UNEP/OzL.Pro/ExCom/66/51  
15 mars 2012

**COUTS DIFFERENTIELS DE LA MODERNISATION DE L'EQUIPEMENT  
NECESSAIRE A LA FABRICATION DES ECHANGEURS DE CHALEUR  
(DECISIONS 61/45 ET 62/61)**

**A STUDY OF FIN AND TUBE COIL MANUFACTURING CHANGES FOR CONVERSION  
FROM R-22 TO R-410A**

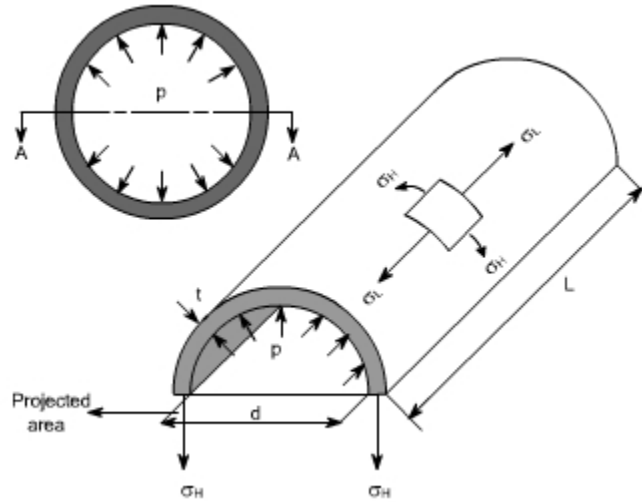
**WB comments:**

1. While we agree that fatigue test is a good method to test the system under simulated normal operating condition, we do not think it adequately addresses the above condition that could occur during shipment. If coils cannot withstand the typical burst test pressures needed to qualify R-410A coils, the recommendation should have been to find an engineering solution to solve the problem, instead of changing a testing method. Extending the result of the fatigue test analysis to
